**SUBJECT: JAMES A. FITZPATRICK NUCLEAR POWER PLANT – STAFF ASSESSMENT
OF RESPONSE TO 10 CFR 50.54(f) INFORMATION REQUEST – FLOOD-
CAUSING MECHANISM REEVALUATION (TAC NO. MF6106)**

STAFF ASSESSMENT BY THE OFFICE OF NUCLEAR REACTOR REGULATION

JAMES A. FITZPATRICK NUCLEAR POWER PLANT

Figure 3.2-1 Local Watershed and unnamed stream course (Source FHRR Figure 3-1). Note: southern watershed (blue cross-hatched area) is modeled by licensee using HEC-HMS, which provides runoff to northern watershed (red area) is modeled by licensee using FLO-2D.

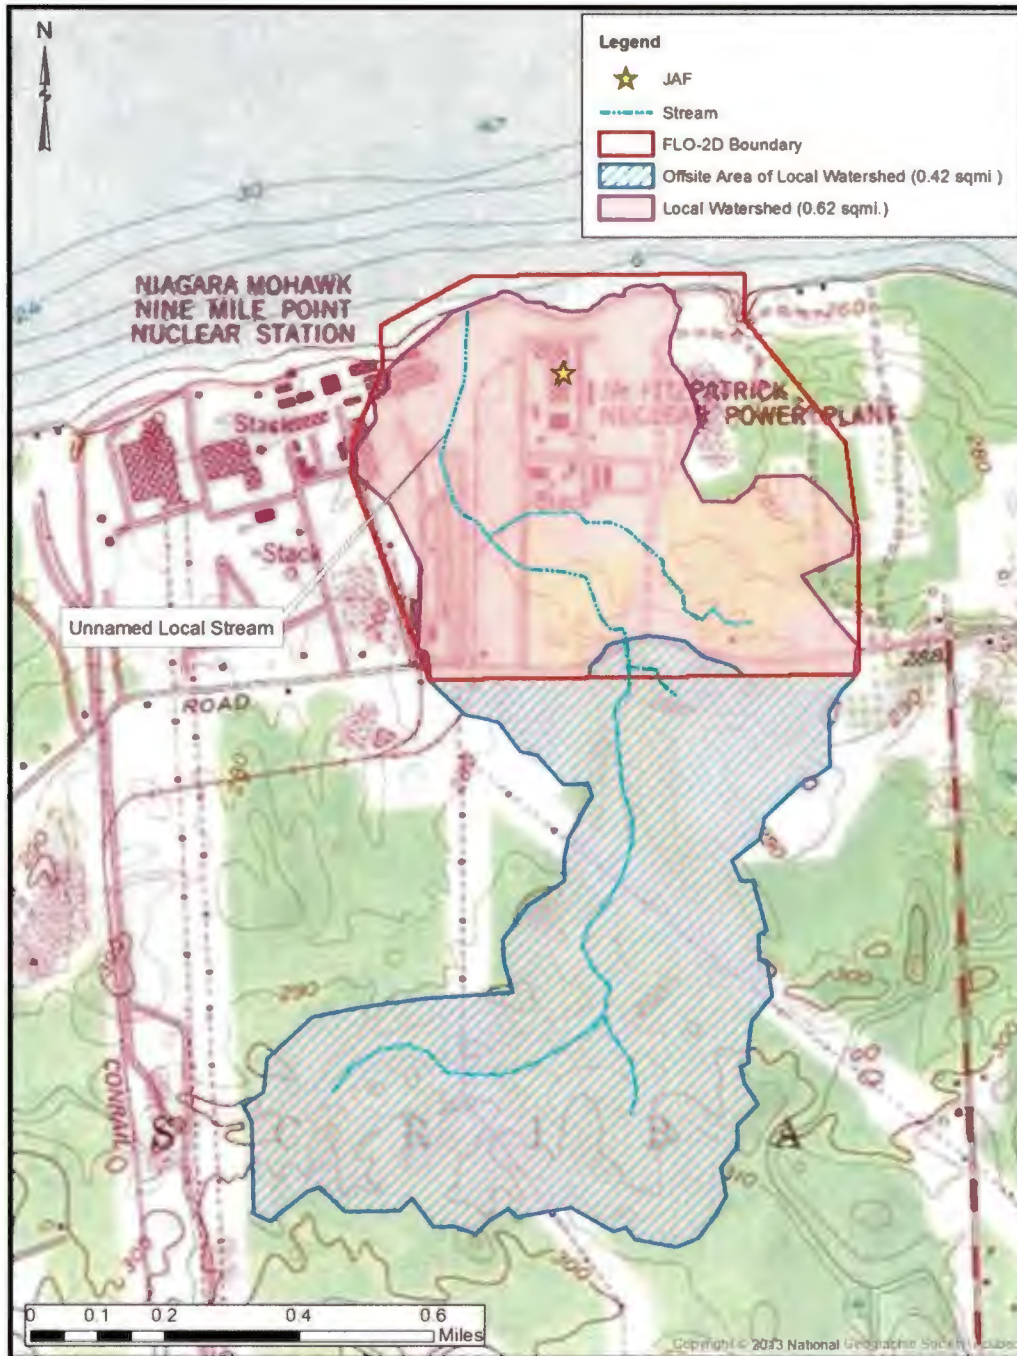
The streams and rivers flooding assessment of the site is focused on an unnamed stream that flows along the west side of the property. The stream drains a watershed comprised of onsite and offsite areas totaling 0.62 mi² (Figure 3.2-1). The offsite upper watershed is to the south of the property. Most of the onsite areas, including the power block, drain into the unnamed stream. The unnamed stream is not gaged.

The licensee created a HEC-HMS model of the local watershed, which includes most of the FitzPatrick site as well as offsite areas shown on Figure 3.2-1, using the PMF along with conservative assumptions of wet antecedent moisture conditions and an impervious surface with no precipitation losses. Non-linearity adjustments were applied. The peak discharge from the local watershed to Lake Ontario was 2,340 ft³/s.

The staff reviewed the hydrological setting of the FitzPatrick site and confirmed that the unnamed stream was the only perennial stream that has the potential to cause PMF inundation of the site. The staff reviewed the site topography and found that the licensee delineation of the site watershed was reasonable. The staff's review of the FLO-2D model used in the PMF analysis is the same as was reviewed in the LIP analysis. Discussion of staff's review is in Section 3.2 of this report and is not repeated here. The staff reviewed the licensee use of HEC-HMS to develop watershed runoff as an input to the FLO-2D model and determined that its use was appropriate.
